Project: Mankato to Mississippi River Project  
23-157

**Supplemental Information Inquiry 2**

Project: Mankato to Mississippi River Project  
23-157

Figure 3:

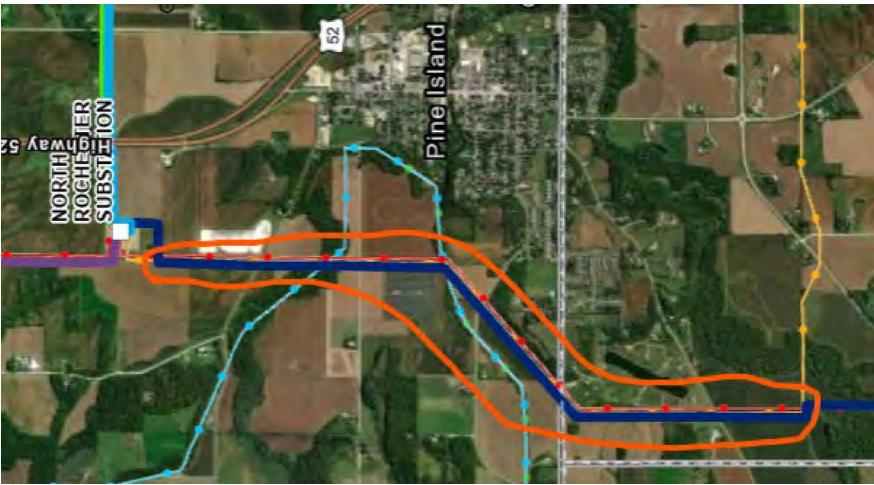
6. This information request corresponds to what the EIS refers to as Segment 4 West. The application indicates that Route Option 4 West would not be double-circuited. However, Xcel indicated in your July 3<sup>rd</sup>, 2024 letter (when requesting the addition of the Route Option 4 West-A) that upon further coordination with Dairyland Power Cooperative and Rochester Public Utilities, double-circuiting would be possible with the existing 161 kV line. Xcel also noted in your November 27, 2024 response to Supplemental Information Inquiry #2 that "If Segment 4 West is selected approximately 3.3 miles of the new line would be double-circuited with the existing North Rochester to Northern Hills 161 kV line." Please confirm the analysis in the EIS can

now assume that the portion of Route Option 4 West circled in orange below would be double-circuited with an existing 161 kV line if selected.

That is correct. For Route Option 4 West, the proposed 161 kV line would be double-circuited for approximately 3.3 miles with the existing 161 kV line as described. In the initial application, our understanding was that the 161 kV lines could not be double-circuited with the proposed 345 kV transmission for reliability reasons, however, after additional evaluation it was determined that they could be double-circuited without impacting system reliability.
